Metropolitan Climate Action Plan

*Final Program
Environmental
Impact Report*

May
2022

SWP GHG Emissions

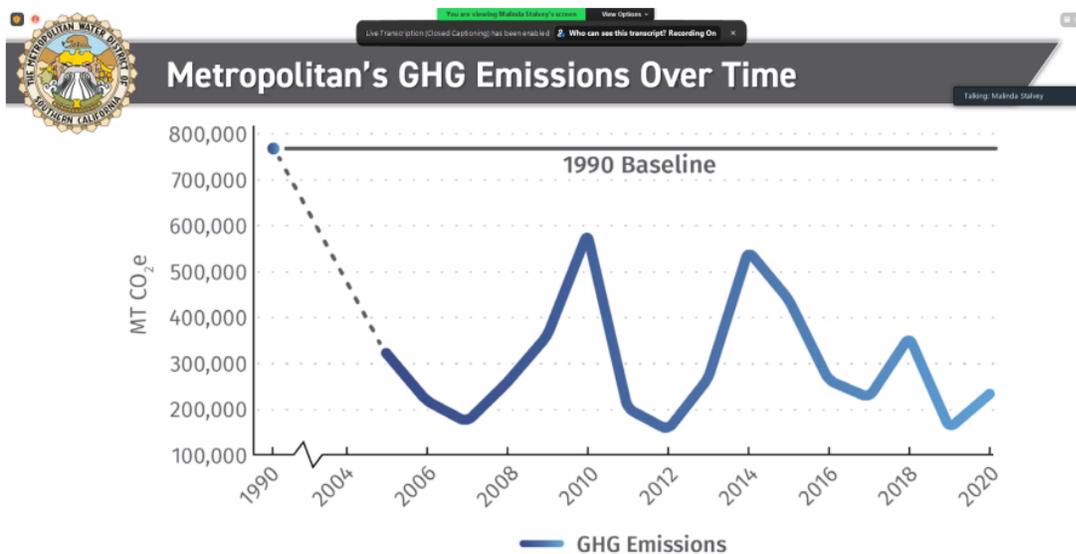
We will not focus so heavily on the energy and greenhouse gases (GHG) components of the CAP, but we have a few comments regarding the State Water Project (SWP). We understand that MWD does not plan to count the GHG from the SWP because they are counted by the State, but MWD should include these numbers in its reports for several reasons:

1. MWD must have an accurate understanding of their energy use when weighing the pros and cons of SWP-related projects such as the Delta Conveyance project, Sites Reservoir, and operations and maintenance needs, especially given the state’s and MWD’s goal of carbon neutrality. Board members, and the public alike, must have a more complete picture when making decisions on such expensive and controversial projects.
2. The cost of energy used in the SWP, especially given the effects of subsidence on the California Aqueduct, are passed along to ratepayers, and presenting the full scope to ratepayers is part of the transparency and openness of the new general manager’s tenure.
